# Office Action Summary

09/526,547

Fedida

**DETAILED ACTION*****Claim Rejections - 35 USC § 102***

LAU et al (Fig. 3 shown below) discloses:

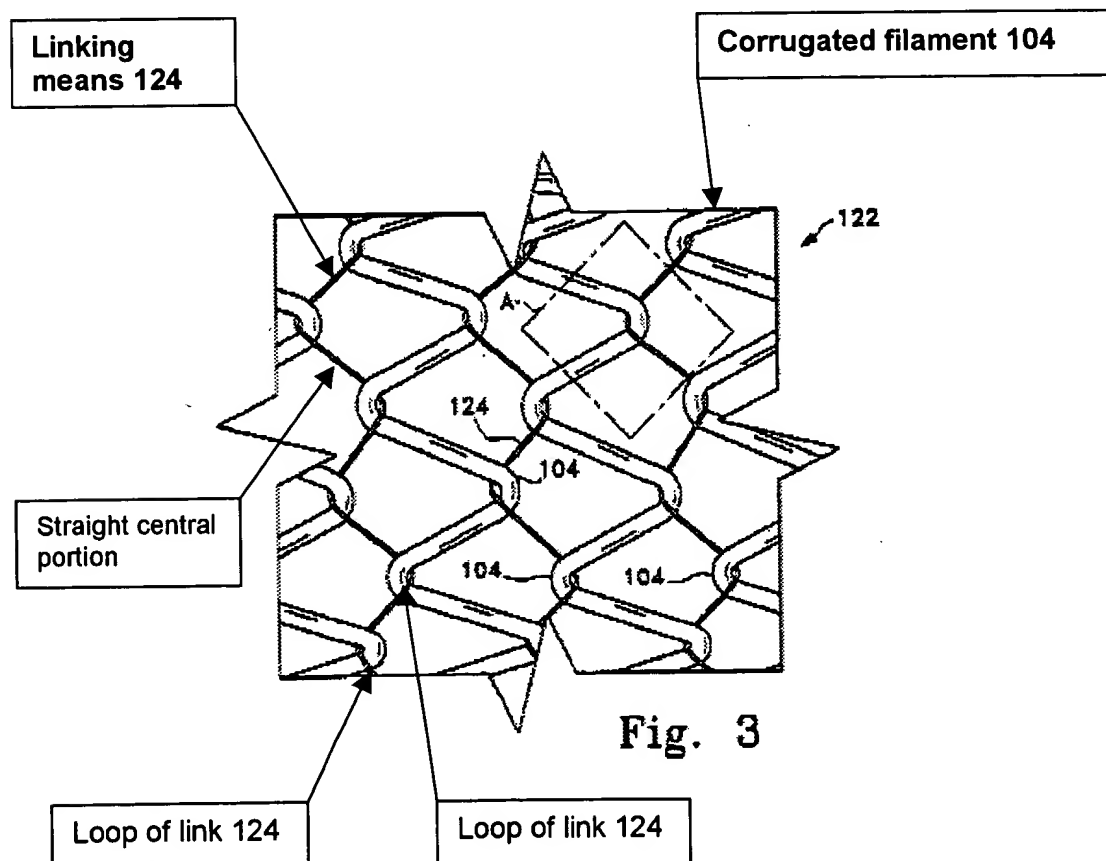
A/ corrugated filament 104, link 124 having two loops to entrap, with some clearance, two corrugations to link them together (read on claim 1, present invention);

B/ link 124 including a straight central portion and two loops connecting two corrugations which do not lie in a same plane. Said two loops defining two different plans (read on claims 2 and 5, present invention);

C/ at the ends of link 124, at least one closed loop is made to fix link 124 and a corrugation (read on claim 6, present invention);

D/ at least one loop of link 124 is **partially closed** to entrap corrugation 104 (claim 7; present invention).

E/ at least some of the corrugations 104 are zig-zags (claim 8; present invention);

F/ at least one of the link 124 is made of gold or platinum which either is a radiopaque material (claim 10; present invention).
